**Design Review Committee**  
**March 4, 2010**

**SUBJECT:** **Case 15842: Site Plan Approval - 1652, 1656 & 1662 Barrington Street,  
Halifax**

Application by Starfish Properties for the redevelopment of 1652, 1656 and 1662 Barrington Street through the Site Plan Approval process for Downtown Halifax.

1 1652 BARRINGTON ST. BUILDING SECTION  
SCALE: 1/4" = 1'-0"

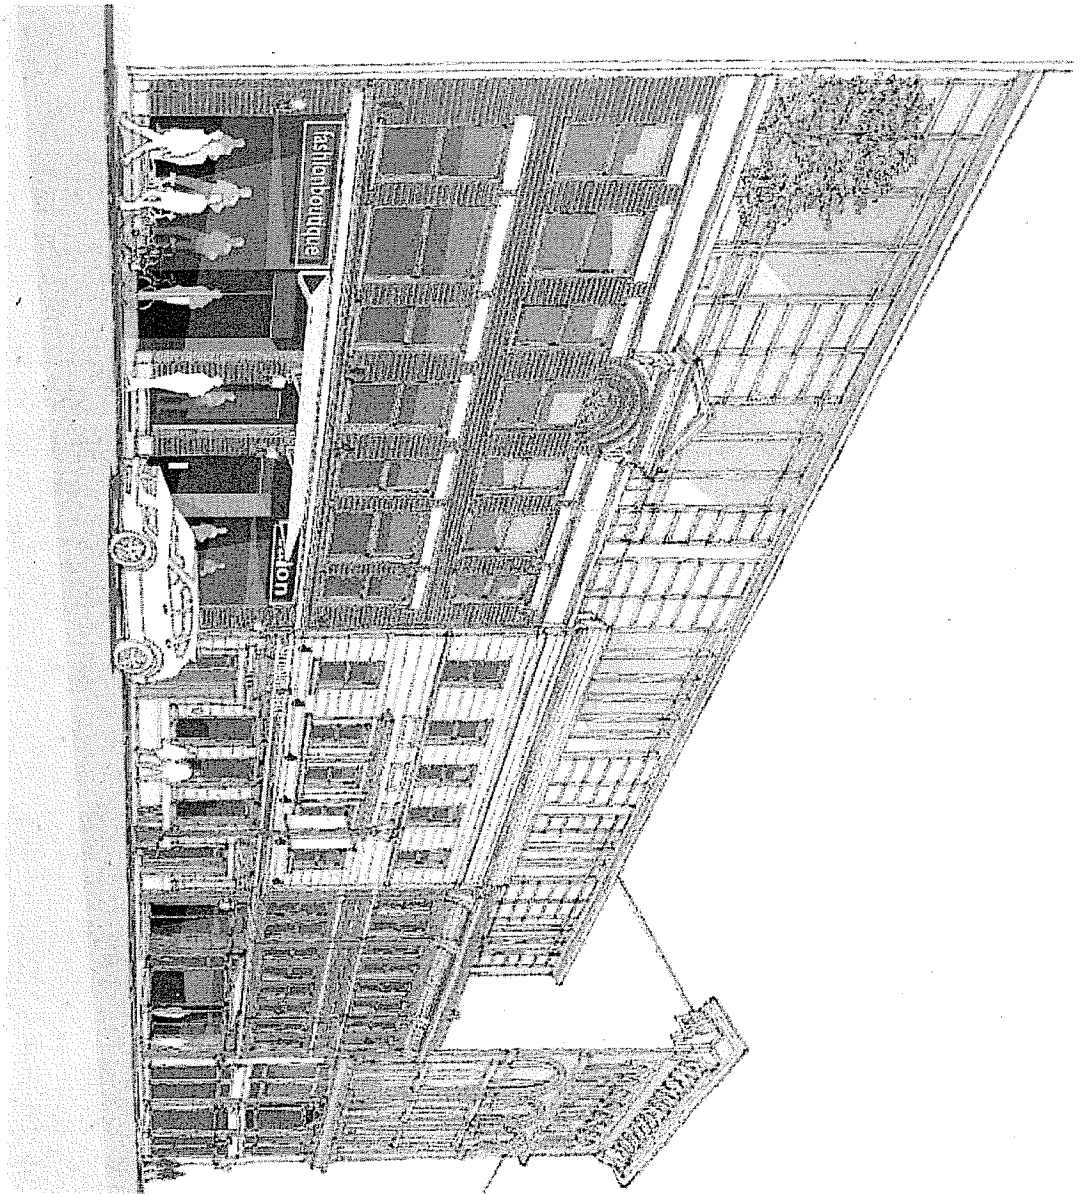
An upper storey streetwall stepback variance is being requested under Section 3.6.5 of the Design Manual to allow for the installation of a 3 foot 6 inch (88.9 mm) high frameless and rail-less tempered glass guardrail behind the existing parapet of 1652 Barrington Street. The variance is required as the guardrail is located within the required 3 metre minimum stepback from the existing streetwall.

In this case, the variance has been requested to allow for the installation of a frameless and rail-less tempered glass guardrail behind the existing parapet of 1652 Barrington Street. The absence of a frame or rail, and the exclusive use of glass will make the guardrail almost invisible from the street. Therefore, the objective and guidelines of the Design Manual will be met.

Allowing the guardrail will permit the rooftop to be accessible to the building's occupants and therefore turn dead space into useable space. The modification would therefore result in a positive benefit.

1 ROOF LEVEL PLAN  
Scale: 1/4" = 1'-0"

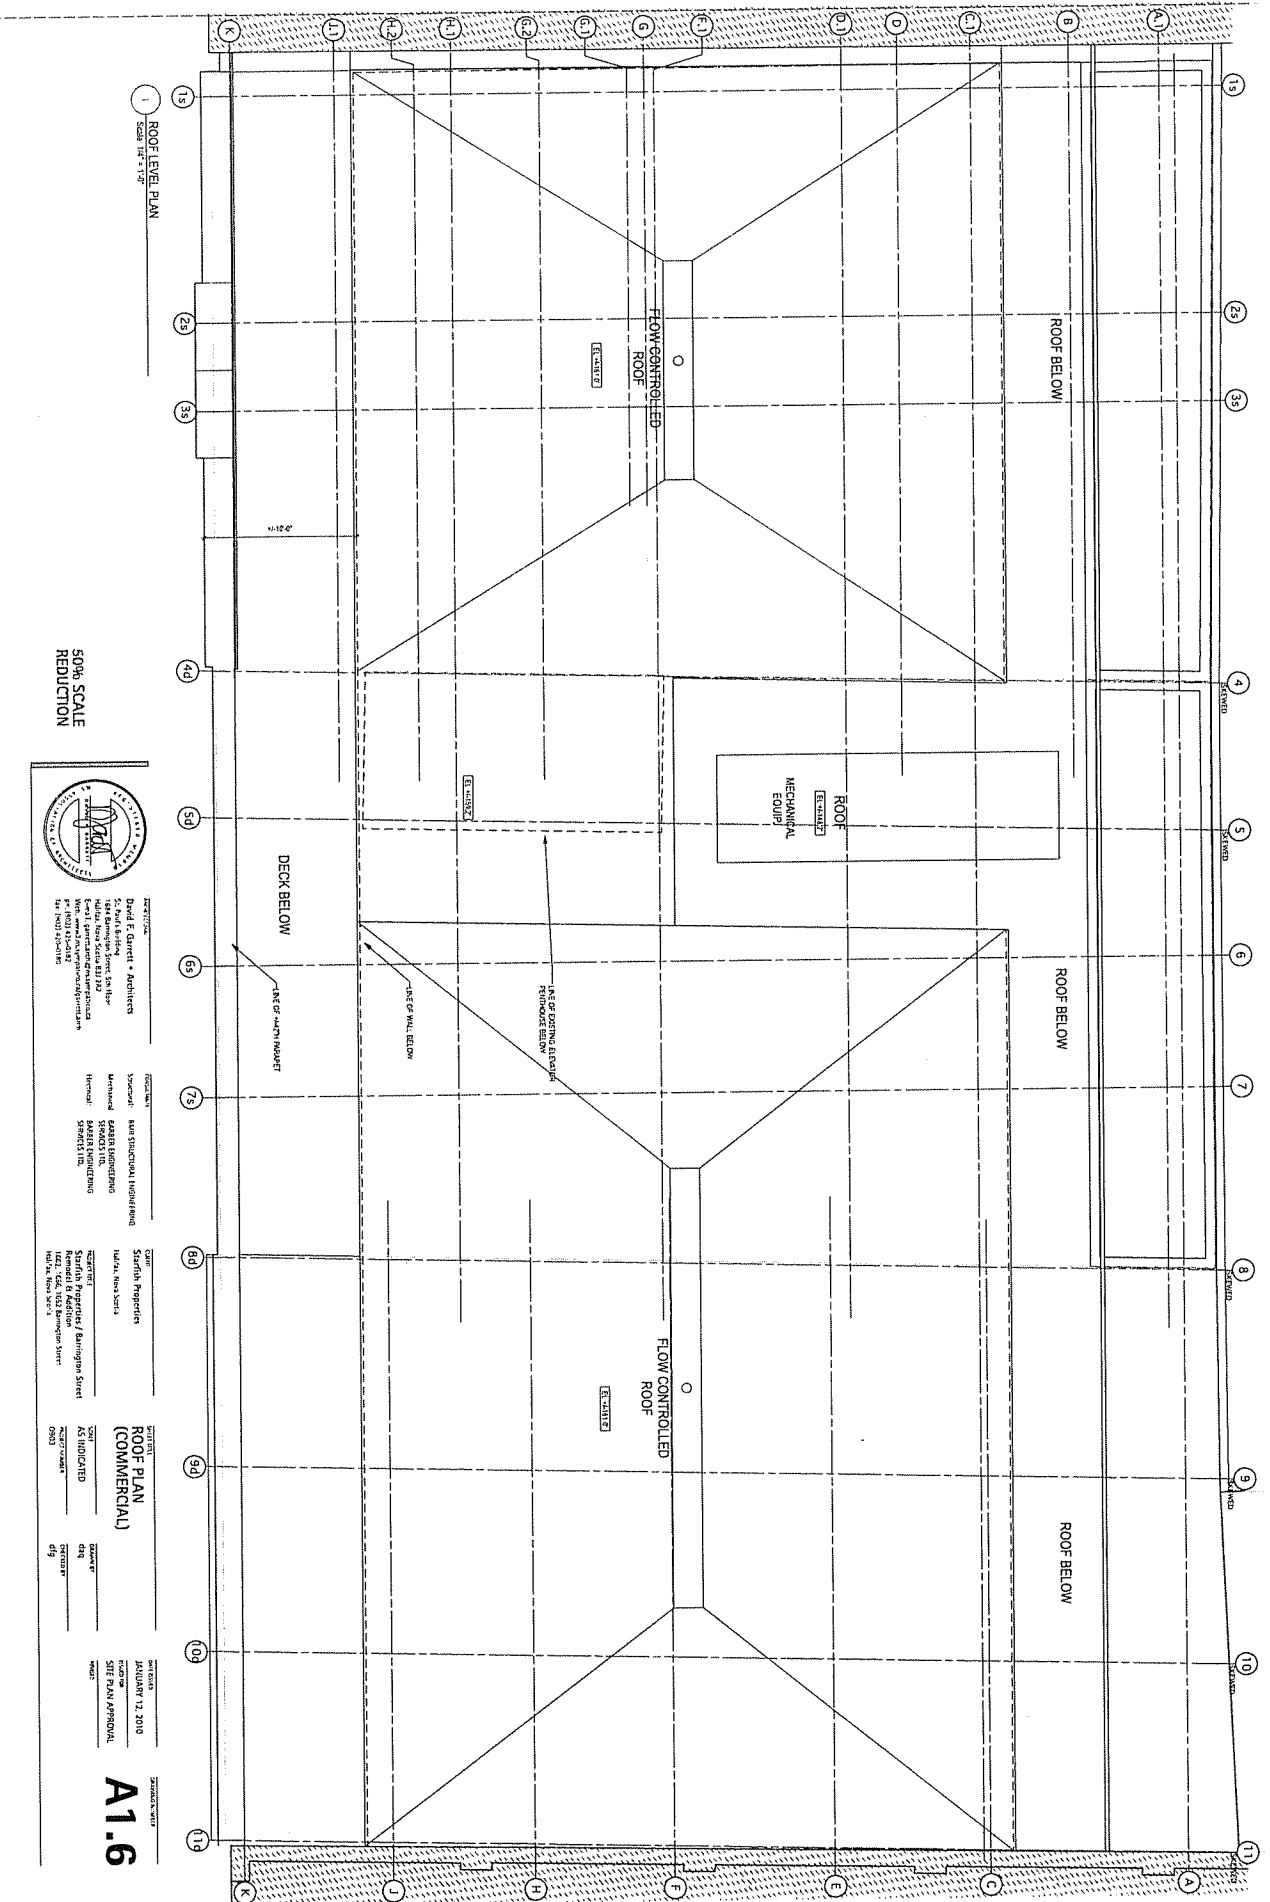
Landscaping treatment of all flat rooftops is required under the Design Manual. Special attention is to be given to landscaping rooftops in this Precinct as they are preeminently visible from Citadel Hill. The majority of the roof has a low slope just exceeding 1:12, therefore it does not meet the Land Use By-law definition of definition of a "flat roof". This portion of the roof top will be constructed out of conventional roofing material. Conventional roofing materials will also be used on the lower portion of the roof at the rear of the addition where the mechanical equipment will be located.

The landscaping proposed for the flat portions of the roof is comprised of a deck positioned within the stepback area above the third storey. The project architect has indicated to staff that the deck will be accessible to the building's occupants from the fourth floor and will be landscaped with pavers and plantings in potted containers. Given the project's location and its ability to be viewed from Citadel Hill, the proposed rooftop landscaping treatment could be improved. It does, however, meet the technical requirements of the Land Use By-law and Design Manual and therefore staff accept the proposed design.
